From: [REDACTED]
To: [MCP-Chair](#)
Cc: [Jumoke Adediran](#)
Subject: Testimony against proposed removal of footpath at Bloom Village
Date: Monday, June 16, 2025 11:21:16 AM

I registered this morning to testify at this Thursday's planning board meeting on item 13 (about Bloom MV, Site Plan Amendment No. 82017013F and FCP No. F20240970). Please see my attached written testimony and let me know if there is anything else that you need from me.

Statement of Justification Bloom MV I-VI Site Plan Amendment 82017013F

Montgomery County
Planning Board
Bloom MV
Re:Site Plan Amendment #82017013F
Forest Conservation Plan

Figure 1: Flood from Stormwater Pond to Lake, to Cabin Branch

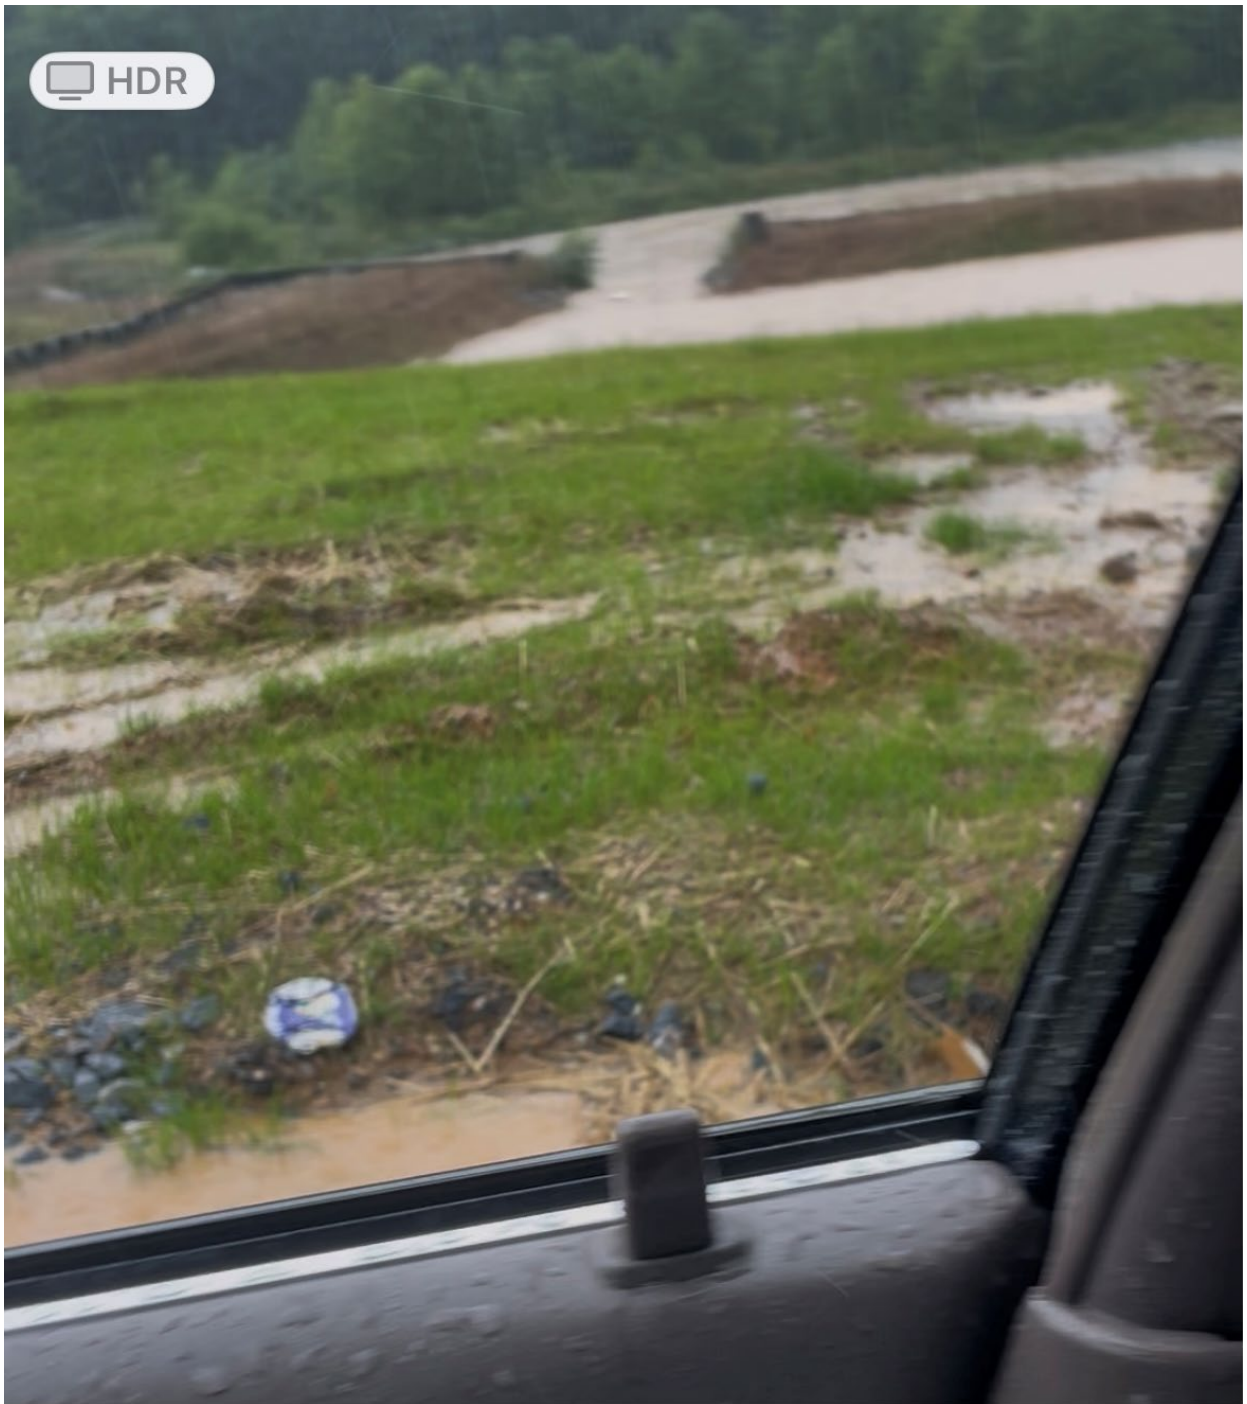
In the past, the planning board dictated what we could talk about (see enclosed letter) and they created a speedy Masterplan Timeline. The streams, and roads were omitted. (see enclosed Map). The thing remaining to be completed for Bloom MV is the Forest Conservation, tree planting and existing paths. Already the land has been clear-cut and flooding into the existing ponds is inundating Cabin Branch Stream. The Forest Conservation Plan is contingent upon everything else here, so I have no comprehension of what the planners are doing. Enclosed are my pictures of the construction site during our recent flood.
